Final Mitigation Plan Six Runs Stream and Wetland Mitigation Project

DMS #: 100170 | Contract #: 0303-01 | RFP: 16-20190303
USACE Action ID: SAW-2020-01964 | DWR #: 20201798 v1
Cape Fear River Basin | HUC 03030006 | Sampson County, North Carolina

SUBJECT: NCDMS Six Runs Mitigation Project - NCIRT Comments during 30-day Mitigation Plan Review, Sampson County, NC

RE: Response to Final Draft Mitigation Plan Comments – Six Runs Mitigation Project (DMS #100170) Cape Fear 03030006; Sampson County, NC; Contract No. 0303-01

Figure 12 - Monitoring

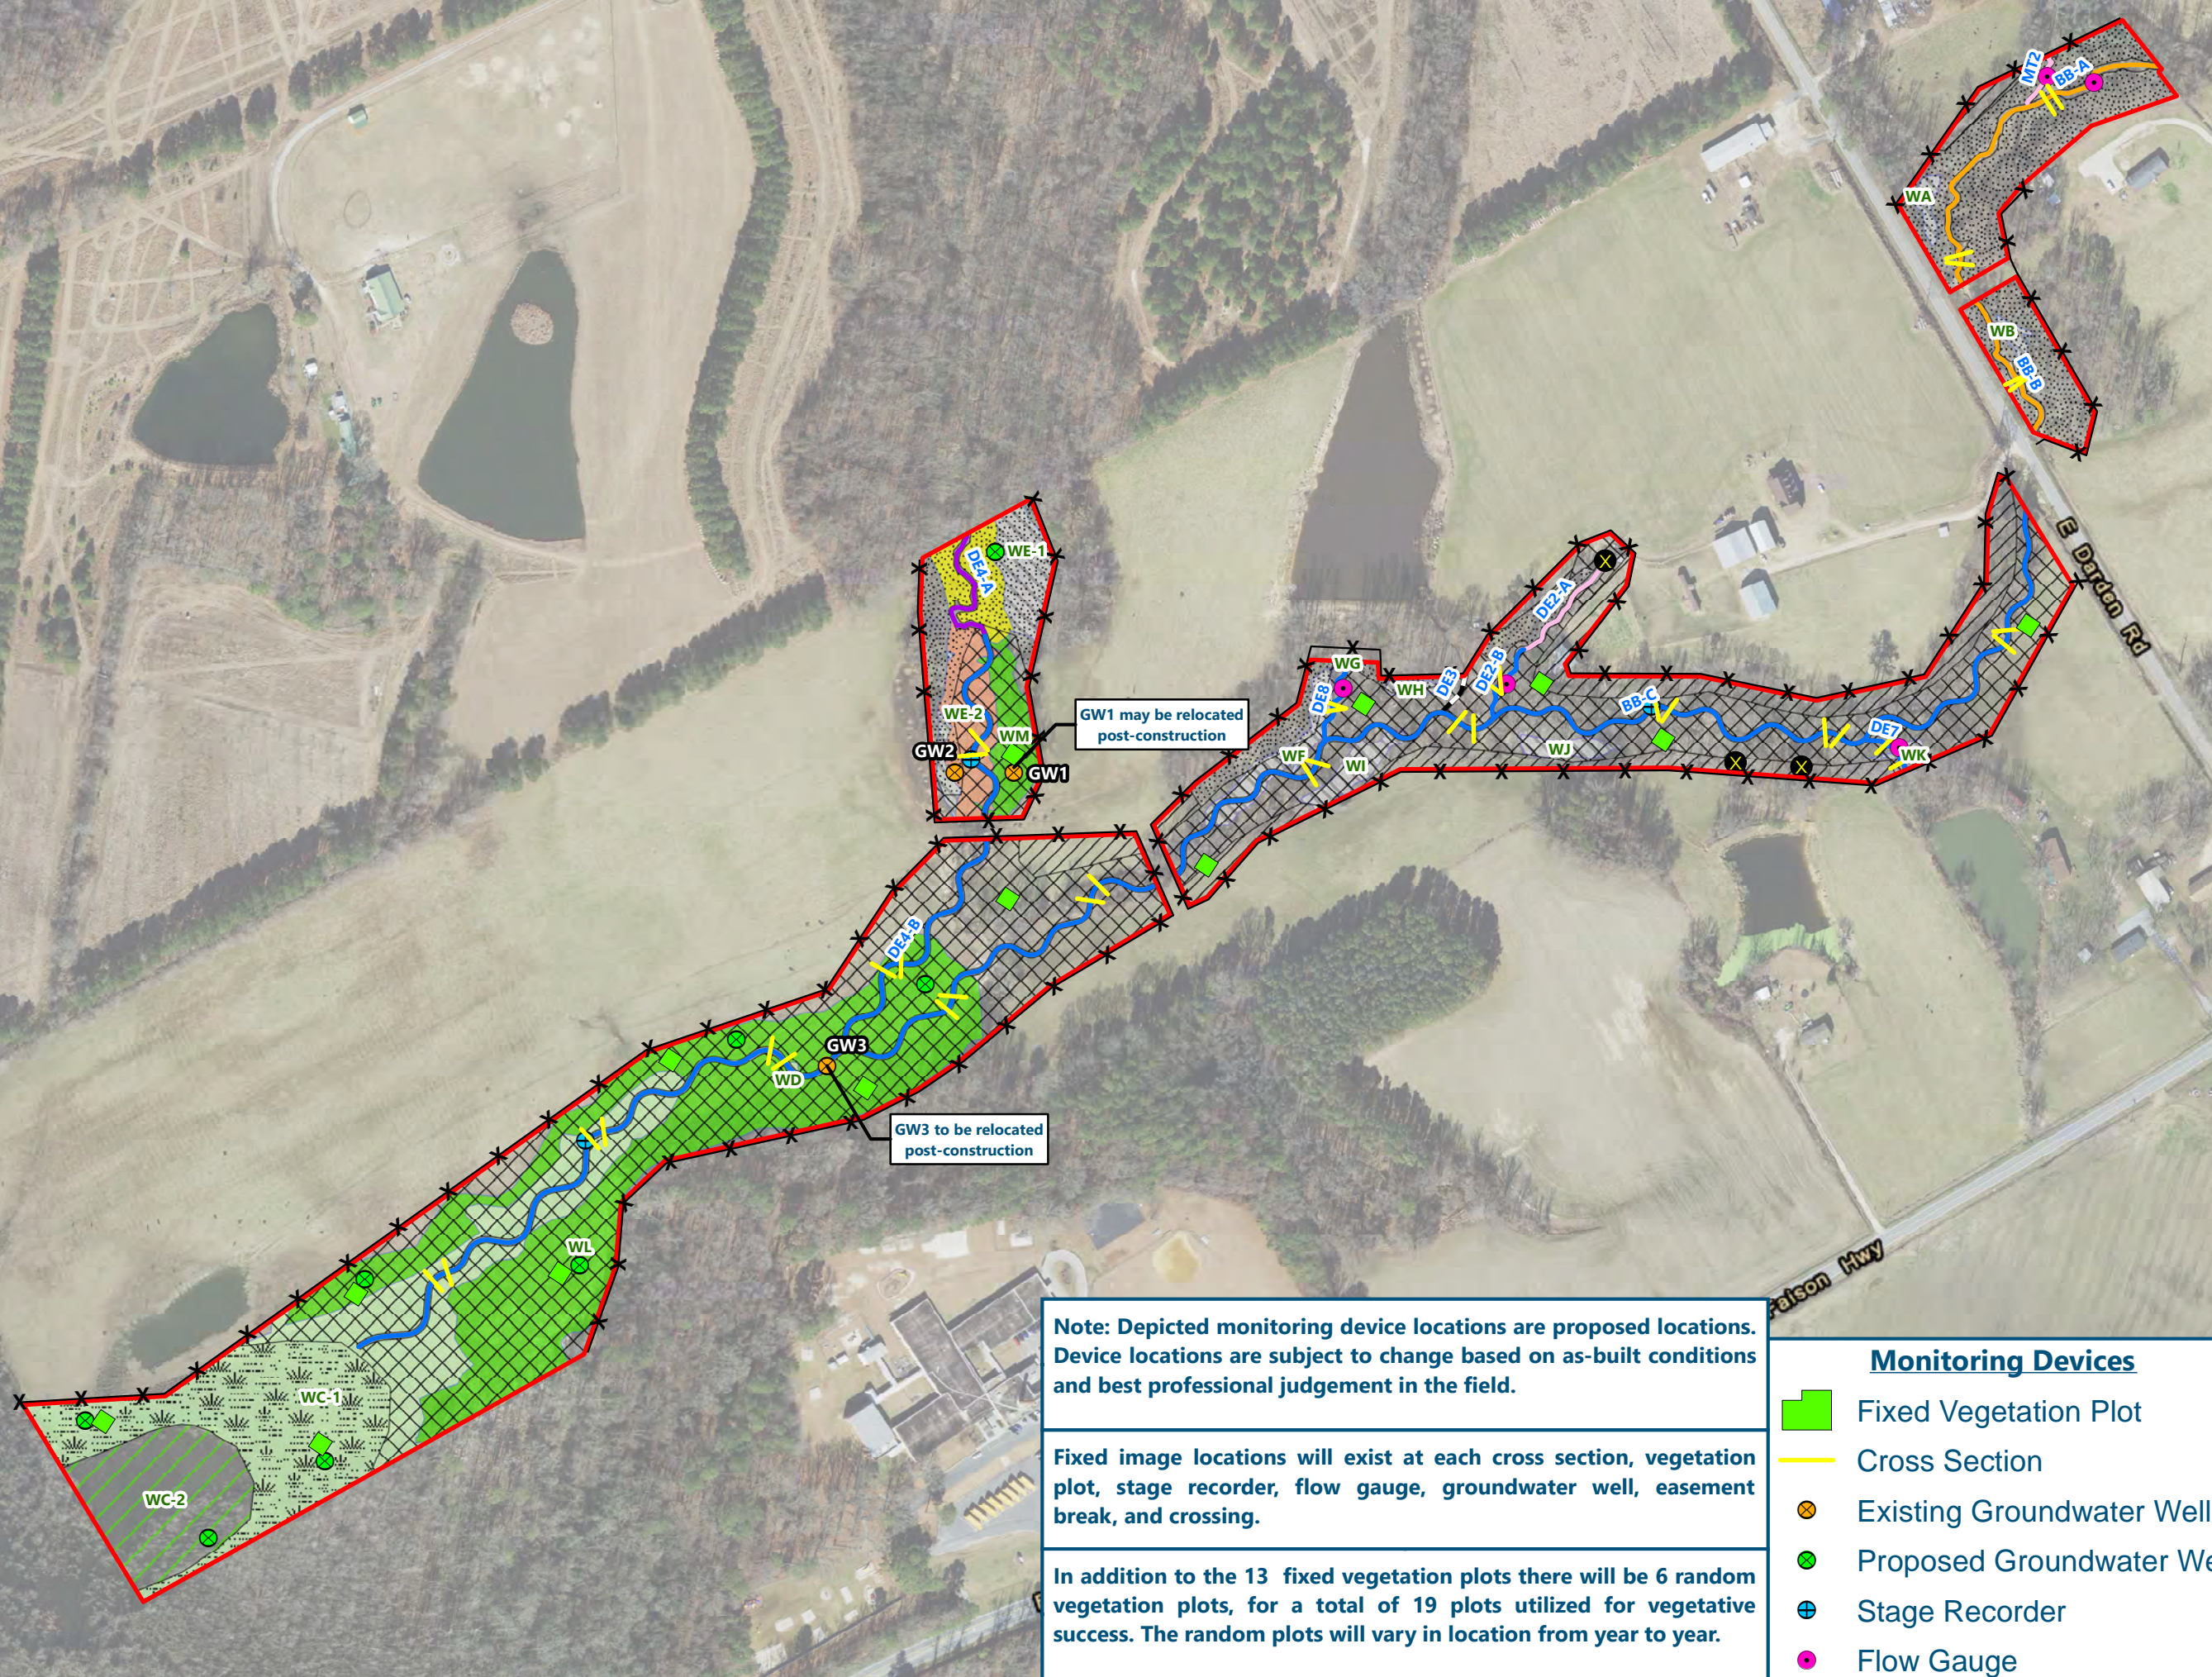
17. Figure 12 Monitoring –
 - a. DWR requests that the groundwater gauge at southern edge of the reestablishment area be relocated near the south corner of the veg plot in the rehabilitation area (I can provide a map mark-up if requested). DWR also recommends considering adding a reference groundwater gauge in the preservation area.

- b. Please add easement break and culvert crossing to the fixed image locations note.
18. Cover Sheet – Site Map blocks S15 & S16 should be S14 & S15.

12. Figure 12: Please ensure that all crossings and culverts are included in photo stations.
13. There is some concern with sediment contributions from the agricultural field above BB-A.

16. Figure 12: At some point during monitoring, please add random vegetation plots or transects in the supplemental planting areas in WA, WB, and WE-1 & 2. WE-2 will be important to document functional uplift (veg monitoring) since hydrology is already at 27%.

2. Figure 12 Monitoring. The location of the flow gauge on BB-A should be moved up closer to the top of the reach to show flow above the confluence of MT-2.

12. Figure 12: Please ensure that all crossings and culverts are included in photo stations. RES will include these photos. The note in **Figure 12** has been revised accordingly.

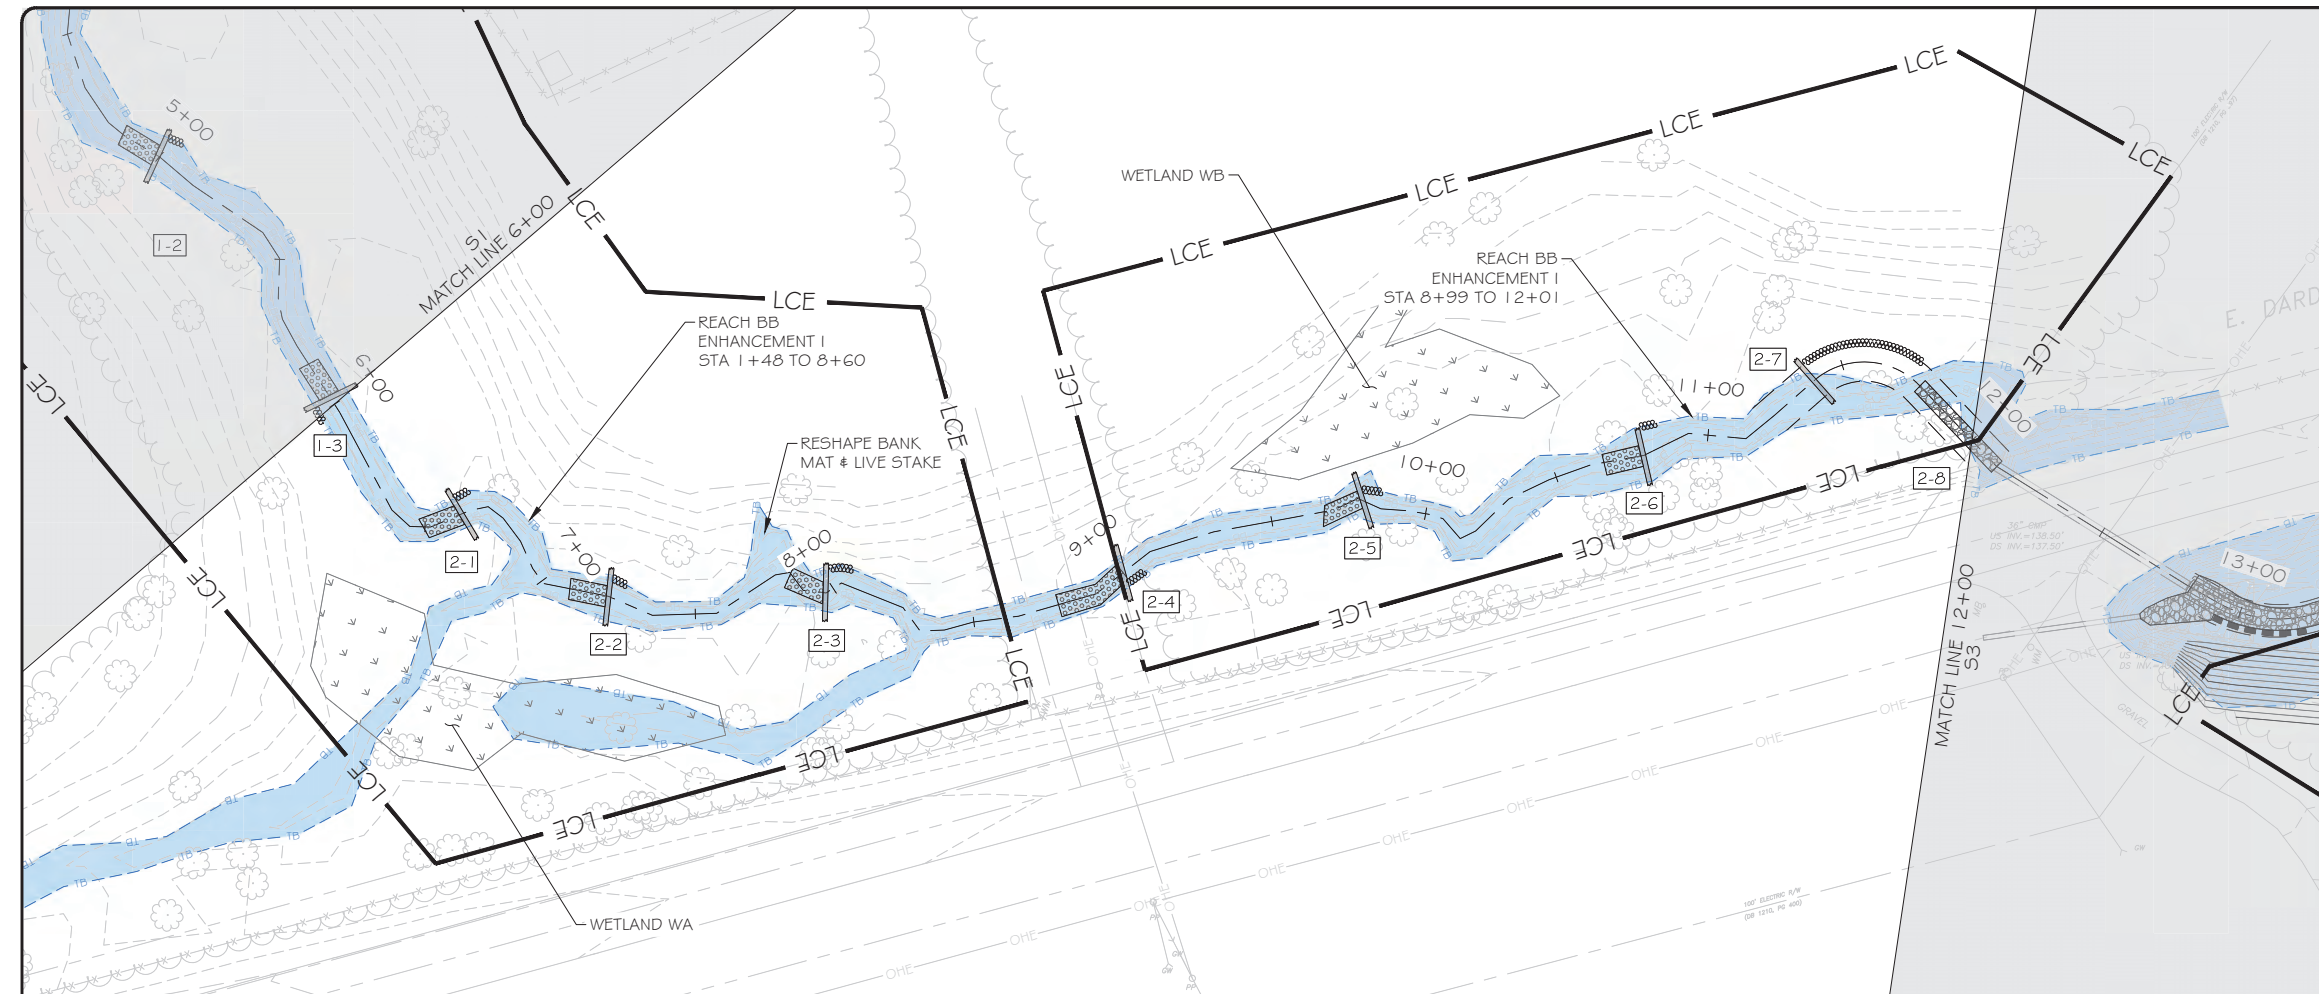
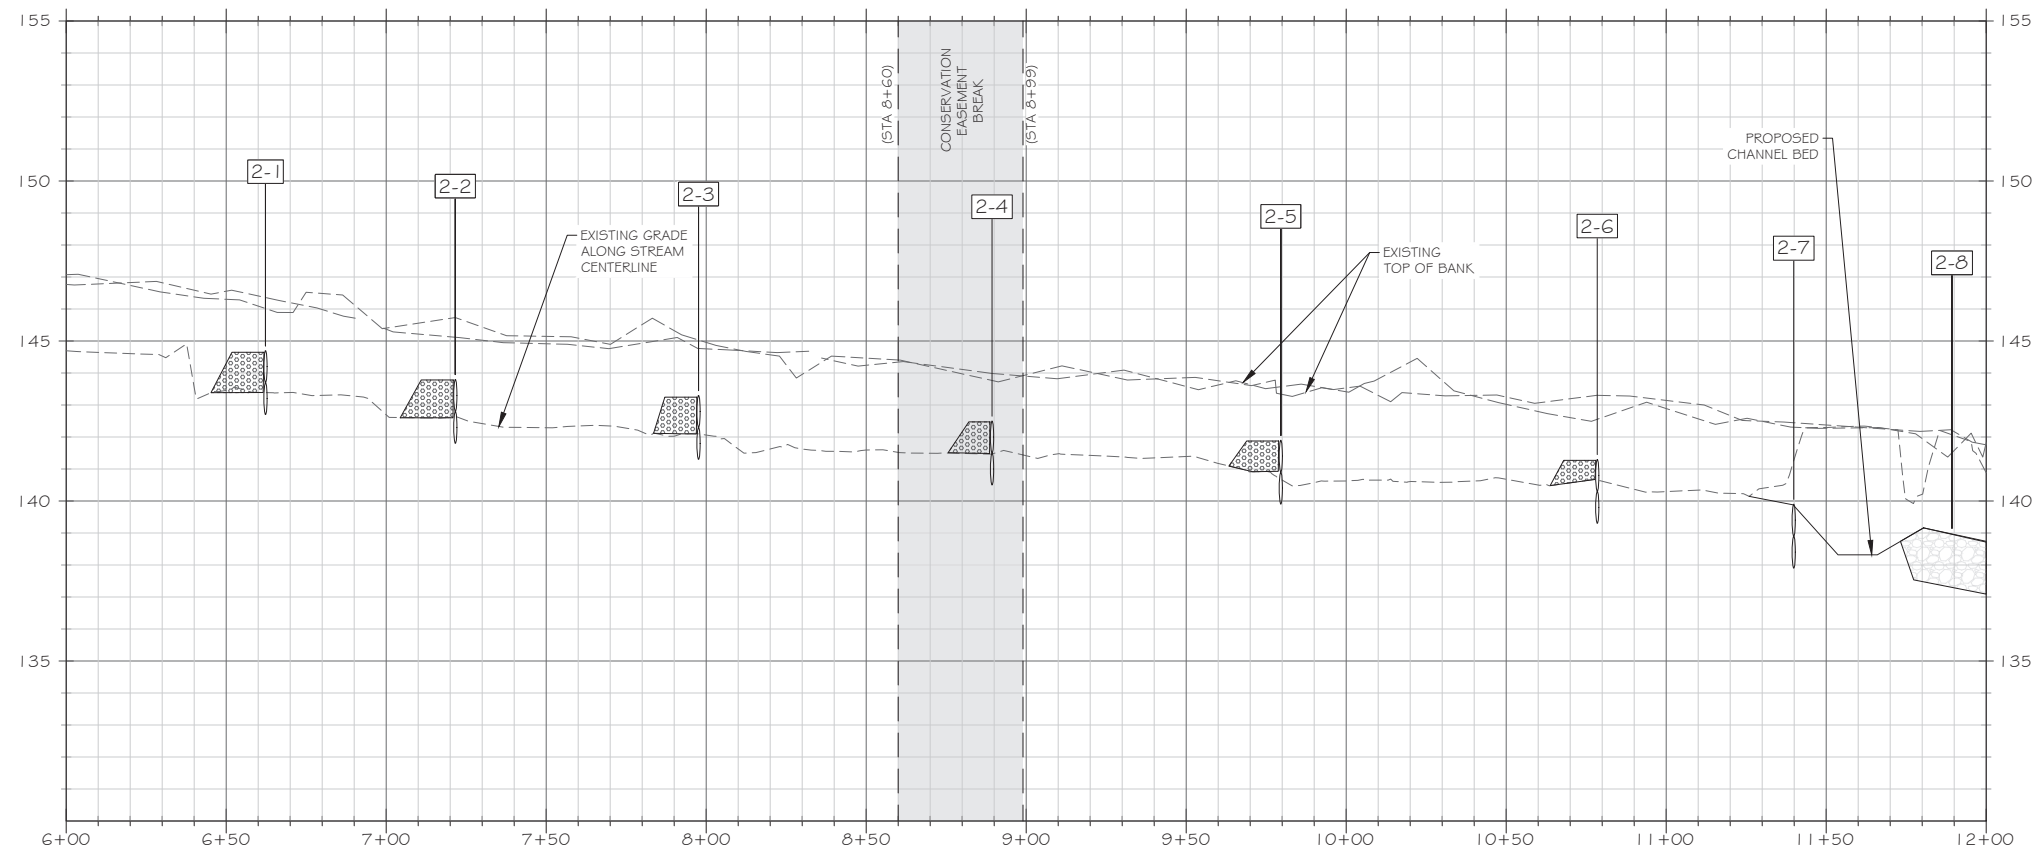
19. Sheets S1 & S2 – No bank grading is shown; however, Sections 3.4.7 and 6.2.1 reference bank grading along BB-A and BB-B. Please confirm whether bank grading is proposed for these reaches, and if so please update design sheets to callout all proposed work. DWR cannot fully support the proposed 1.5:1 ratio for 1,014 LF until we review a revised design plan.

19. Sheets S1 & S2 – No bank grading is shown; however, Sections 3.4.7 and 6.2.1 reference bank grading along BB-A and BB-B. Please confirm whether bank grading is proposed for these reaches, and if so please update design sheets to callout all proposed work. DWR cannot fully support the proposed 1.5:1 ratio for 1,014 LF until we review a revised design plan.

Bank grading along both banks is proposed within the Enhancement I area from STA 3+50 down to STA 11+22; from STA 11+22 to E. Darden Rd., the channel will be restored/realigned. A note has been added to this effect on Sheets S1 and S2 to clarify this work.

NOTES:
 ENHANCEMENT ACTIVITIES SHALL INCLUDE INVASIVE SPECIES MANAGEMENT, SUPPLEMENTAL PLANTING, INSTALLATION OF LOG SILLS AND BANK GRADING. THE LOCATION AND ELEVATION OF LOG SILLS SHALL BE VERIFIED AND ADJUSTED PER FIELD CONDITIONS BY THE ENGINEER PRIOR TO CONSTRUCTION. BOTH THE RIGHT AND LEFT BANK FROM STA 3+50 TO 11+22 SHALL BE GRADED PER DETAIL D2.
